22.107 Moorings - Planning Application ref 221625

Response to comments received on 13.02.23

Ref: Proposed side elevation of Heath Point ref 140083

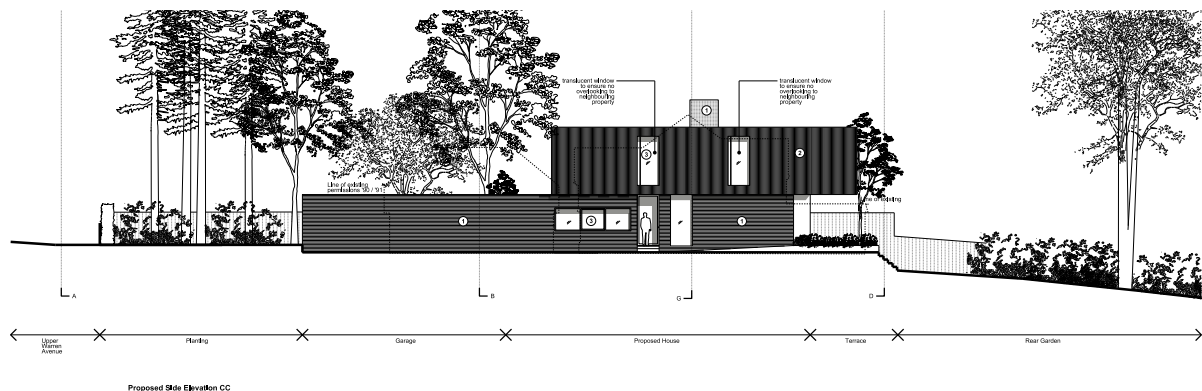
- *The orientation of the neighbouring house no: 16 is close to the proposed end of the replacement property which will be more built up in form than the existing property. The windows at the first floor levels on the proposed east elevation are considered unneighbourly, this could cause a reason for refusal. It would be preferable to use the front/rear outlooks or roof to provide more light into the first floor areas.*

We appreciate that there are three first floor windows to the side elevation, but it is normally deemed acceptable within policy to allow first floor windows for bathrooms (as it is the case for two of the three windows) or indeed other rooms to be within a side elevation as long as these are obscure glazed and either fixed or openable only above the height of 1.7m.

In a recent approval on Upper Warren Avenue, at Norbrook House, first floor side windows to a hall were permitted and referenced in the Officer's report as 'One side facing first floor window is proposed to the side facing elevation serving a hallway, it is considered appropriate to condition this window to be obscure glazed, as it could create opportunities for harmful overlooking to the front garden of Cramond'. Further to this, at High Ridge first floor windows were permitted on the side elevation without objection.

At Heath Point (ref 140083) two full height windows on the west elevation to the Master Bedroom and one full height window on the east elevation to a bedroom were permitted by the Council on the basis that they were translucent glass to prevent overlooking. This is very similar in principle to the window proportions proposed within the application for Moorings, however, the use of bathrooms and a hallway will be substantially less than that of a bedroom and are not habitable spaces in which to dwell.

We would not want to incur a refusal on the basis of these windows but would ask if these could be considered to be allowed if these are conditioned to be obscure glazed and fixed, with only an openable fanlight above 1.7m, which would be compliant with policy. If you could please review the other precedents of these items above that would be appreciated. However, should this still not be deemed acceptable then we would appreciate a further discussion to mitigate any remaining concerns.
